STAKEHOLDER/I&AP QUERY/COMMENT	STAKEHOLDER / I&AP	EAP/SPECIALIST/DEVELOPER RESPONSE
SECOND EIA PHASE COMMENTS AND RESPONSE REPORT		
<p>COMMENTS ON THE DRAFT ENVIRONMENTAL IMPACT ASSESSMENT REPORT FOR THE PROPOSED ALBANY WIND ENERGY FACILITY (WEF), MAKHANDA, EASTERN CAPE PROVINCE The Application for Environmental Authorisation and Draft Environmental Impact Assessment Report (EIAR) Dated May 2021 and received by the Department on 28 July 2021 refer. This letter serves to inform you that the following information must be included in the final EIAR:</p> <p>(a) Listed Activities Please ensure that all relevant listed activities are applied for, are specific and can be linked to the development activity or infrastructure as described in the project description. Only activities applicable to the development must be applied for and assessed. If the activities applied for in the application form differ from those mentioned in the final EIAR, an amended application form must be submitted. Please note that the Department's application form template has been amended and can be downloaded from the following link https://www.environment.gov.za/documents/forms. It is imperative that the relevant

Figure 1: Indalo PE proposed expansion in relation to the Wilderness Value ratings of the region.

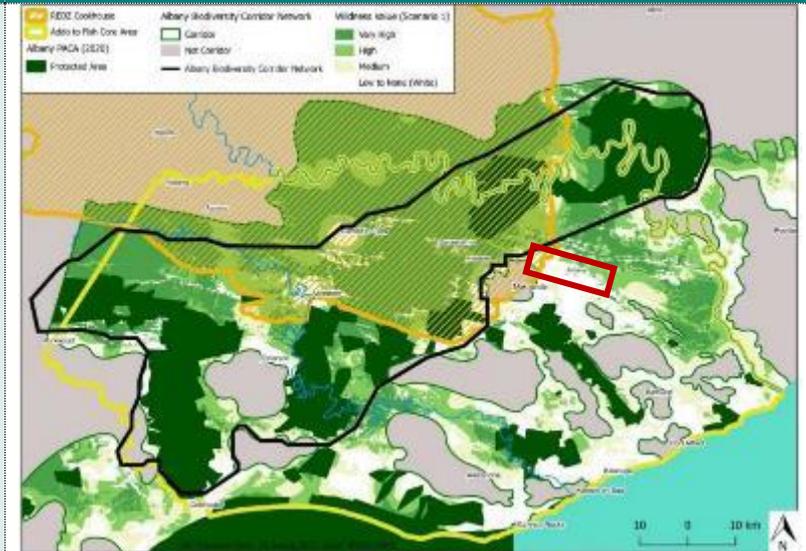
2.3.16 All the purposes in section 17 of NEMPAA apply to Indalo, Great Fish and Addo. The underlined provisions of section 17 require that Indalo and the other Protected Areas must, (i) provide environmental goods and services, (ii) create an environment that is conducive for nature-based tourism, and (iii) ensure ecological sustainable social and economic development takes place. Similarly, the purposes in section 28(2) of NEMPAA apply specifically to the Indalo. This means that Indalo must (i) form a buffer zone between the Addo and Great Fish, (ii) enable the different PGRs inside Indalo to conserve their biodiversity, (iii) protect

The I&AP is suggesting that the Albany WEF would essentially derail the proposed Albany Biodiversity Corridor Network. This assertion is flawed since an operational WEF (Waainek WEF) has been included WITHIN the proposed corridor (see Figure 1 below). In addition to this point, the fact that the Albany WEF is proposed on land regarded as having a LOW “Wilderness Value” would suggest that this land has been excluded as it is not suitable for future expansion purposes. It is assumed that this is due to the conflicting land uses, such as mining, industrial development (such as the Eskom Albany Substation, Eskom distribution powerlines and numerous telecommunication towers). To deprive the current landowners of the economic opportunity of the proposed WEF when their land is not earmarked for inclusion into this plan is neither just nor fair. The proposed Albany WEF would not impose on, disrupt or deter the establishment of the “Albany Biodiversity Corridor Network”.

Figure 1: Indalo PE proposed expansion in relation to the Wilderness Value ratings of the region.

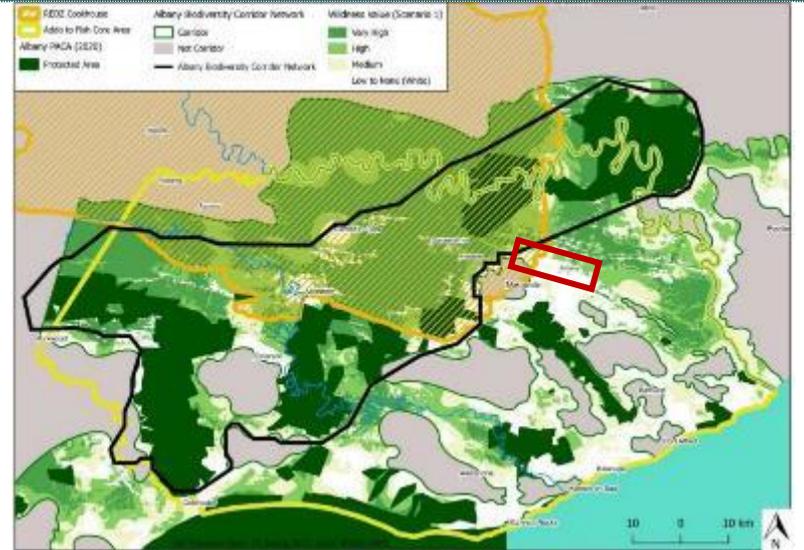
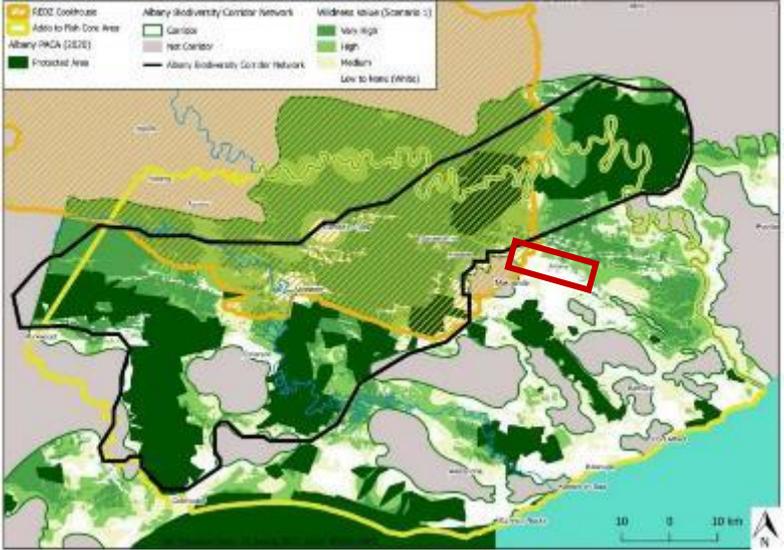
2.3.18 Unlawful and unconstitutional conduct: The recommendation by the EAP in the EIR contains a material legal error that will have an unlawful and unconstitutional legal effect if the DFFE approves the application. The EAP's recommendation to the DFFE to provide conditional environmental authorisation (EA) for the development of the Albany WEF will affect Indalo and the other Protected Areas to comply with their legal obligations under section 17 and 28 of NEMPAA, respectively (as underlined). Indalo members are concerned with nature and wildlife tourism and are managed according to a Protected Area Management Plan and secure funding from internal resources to fund the Protected Area Management Plan in compliance with its obligations, the provisions of conservation and biodiversity legislation and the conditions stipulated by formal management agreements with Government. These

The SIA and EIR were updated to reflect the comments submitted by the various Stakeholders and I&APs, including Pumba PNR (on the Waainek project) and the Kwandwe visitor survey. This was done after the previous round of comments.

FIG. 1. (Color online) Apparent sound power levels (L_{WA} and L_{WALF}) in the reference direction as a function of turbine size. Wind speed is 8 m/s. Regression lines: all turbines included (thin lines), four turbines below 450 kW excluded (bold lines). Black-filled marks are for turbines 1–4.

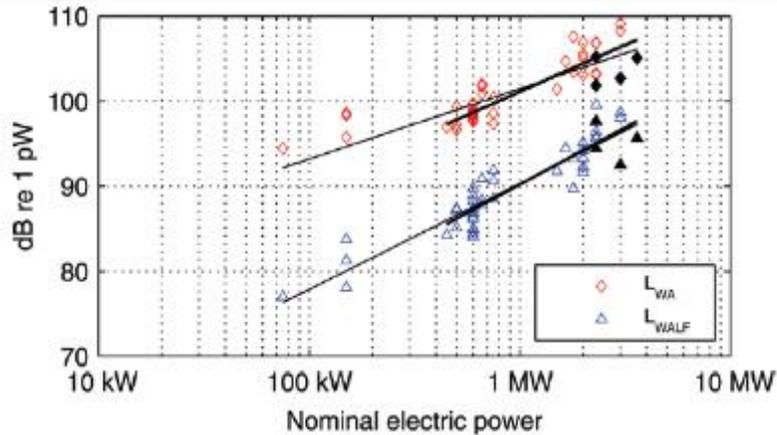
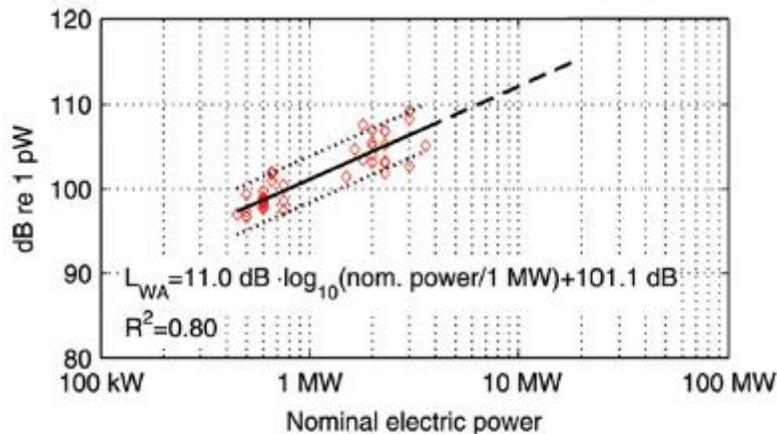
j) It is clear from Møller and Pedersen (2011) that the spread in noise power output is as much as 8dB for three different 3 MW turbines evaluated (and that low frequency noise emissivity is spread similarly). It may be reasonably expected that relative to the reference turbine 3.45

p) Using Equation 5 and above assumption the relationship between apparent sound power level and rotor diameter is derived and plotted below.

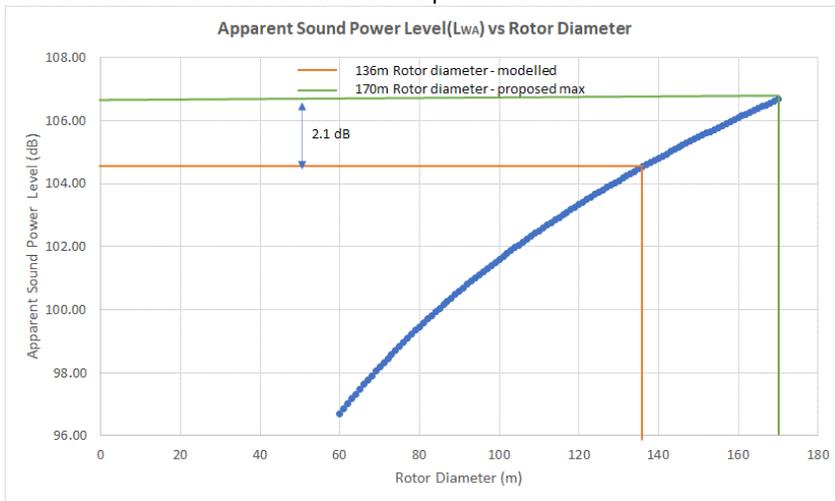
q) The difference in sound power levels between a turbine with a 136m rotor diameter that was modelled and a turbine with the proposed maximum 170m rotor diameter at 8ms-1 is approximately 2.1 dB.

s) "Change in specifications such as hub-height and rotor diameter have an insignificant impact on sound power emission levels" as stated by the noise specialist is false, misleading and raises questions as to the objectivity of the specialist. This has the potential to mislead the authority making the decision.

MAP OF RELATIVE LANDSCAPE (WIND) THEME SENSITIVITY

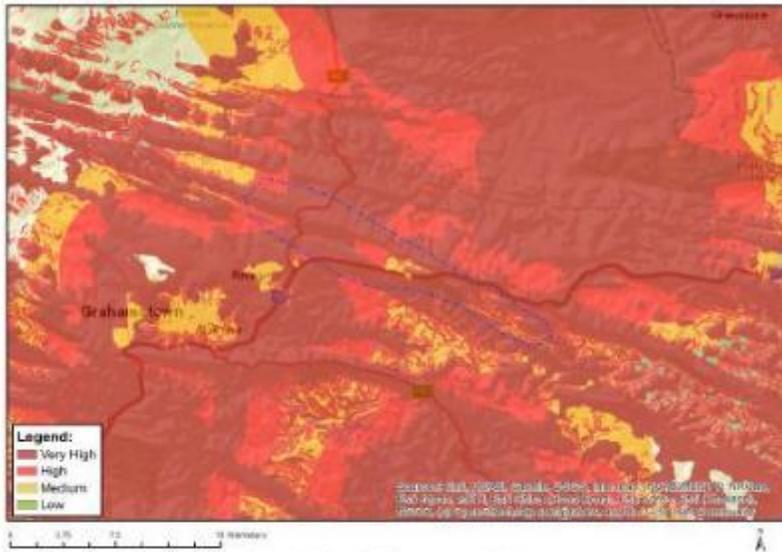
<p>b) Most of the proposed turbines are located outside of the Cookhouse Focus Area, however this does not mean that they fall outside of this area of Very high Visual Sensitivity, in fact, the figure below, from the DFFE National Web based screening tool, shows that most of the development falls within area’s classified as Very high Visual Sensitivity, for reasons, amongst other such as proximity to protected areas and nature reserves.</p>		<p>It is our opinion that the comprehensive VIA has assessed the impacts which concluded that the visual impacts are HIGH for the following sensitive receptors:</p> <ul style="list-style-type: none"> • Kwandwe Private Game Reserve (Indalo); • Kwandwe West Indalo Protected Environment; • Buffalo Kloof Protected Environment; and • Kwandwe Private Game Reserve (non-Indalo).

Also refer to the Specialist Response H4 for expansion on the application of the REDZ 3 screening guidelines to the Albany WEF VIA.
